**Re: ZMAP 2008-0007, Fairfield at Ryan's Corner**

Loudoun Water has reviewed the referenced Zoning Map Amendment Petition and offers the following comments:

**SUBJECT:** ZMAP 2008-0007, Fairfield at Ryans Corner, Second Referral

Figure 4  
Existing Peak Hour Traffic Volumes

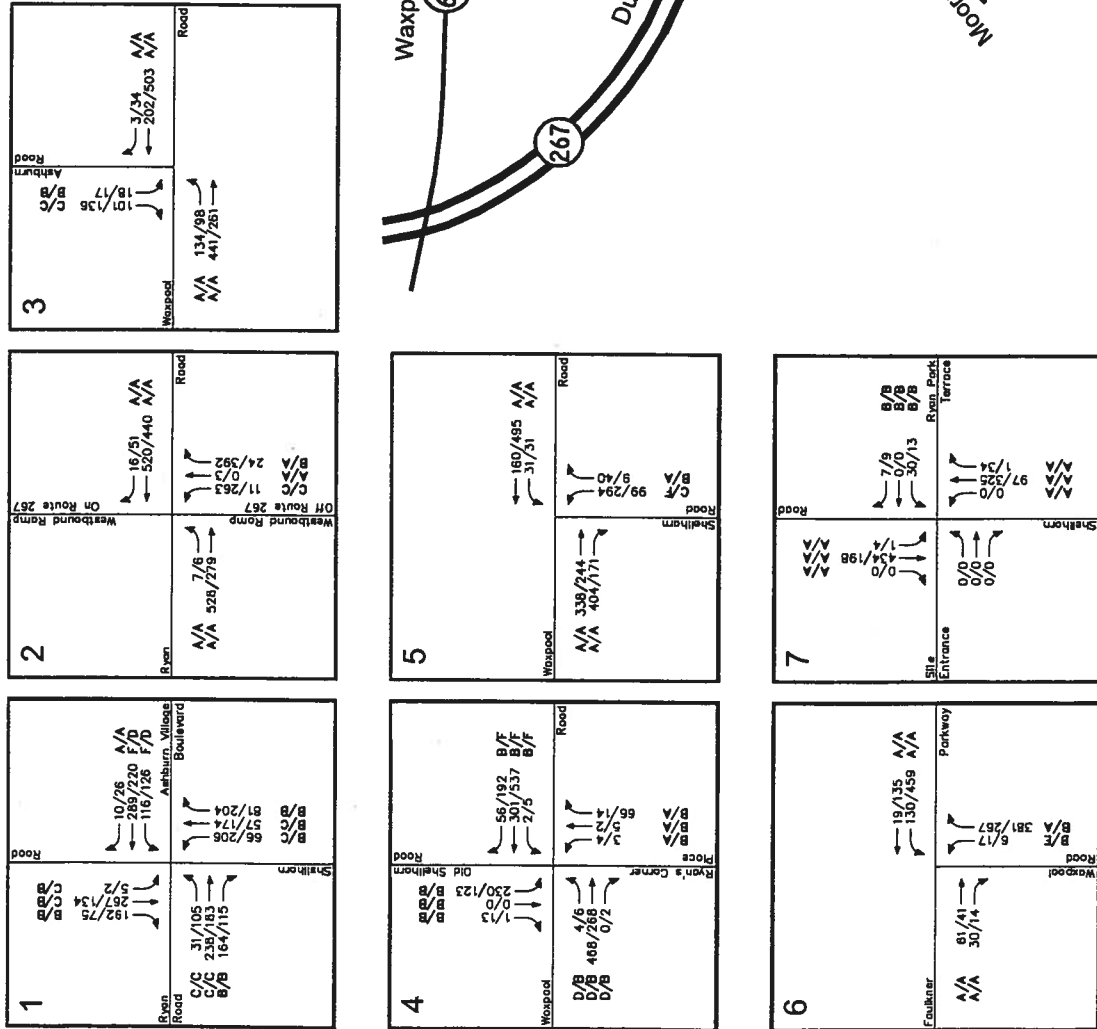
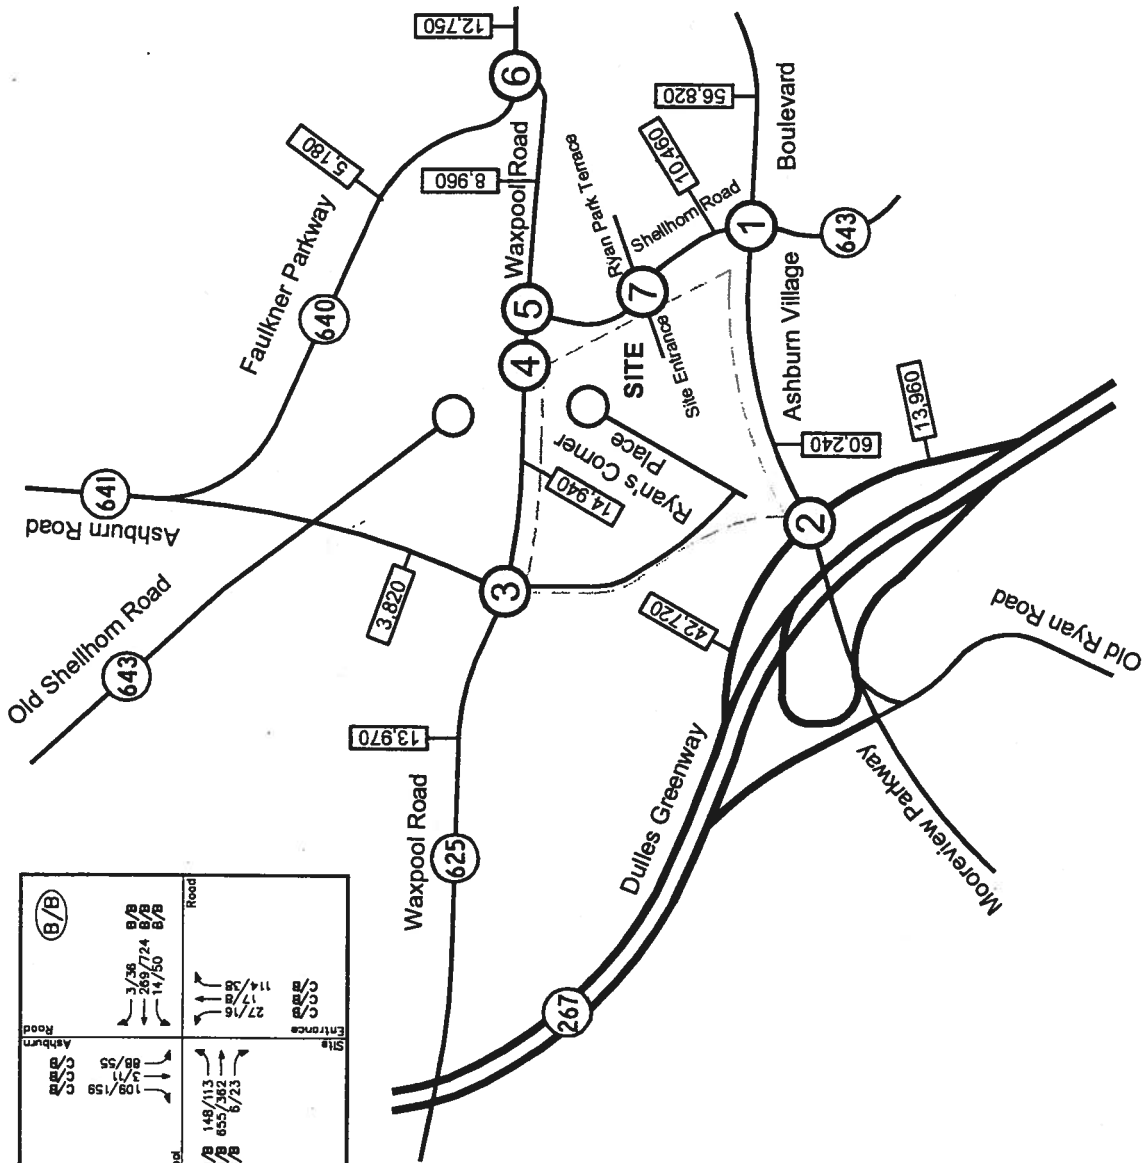
4. Figure 4 Existing Peak Hour Volumes – the data shown for intersections 3, 4, 5, and 7 does not match the raw data in the appendix. Please clarify.
5. Page 11 – Analysis of Existing Conditions – modify notes 1 and 2 given comment 3 above.
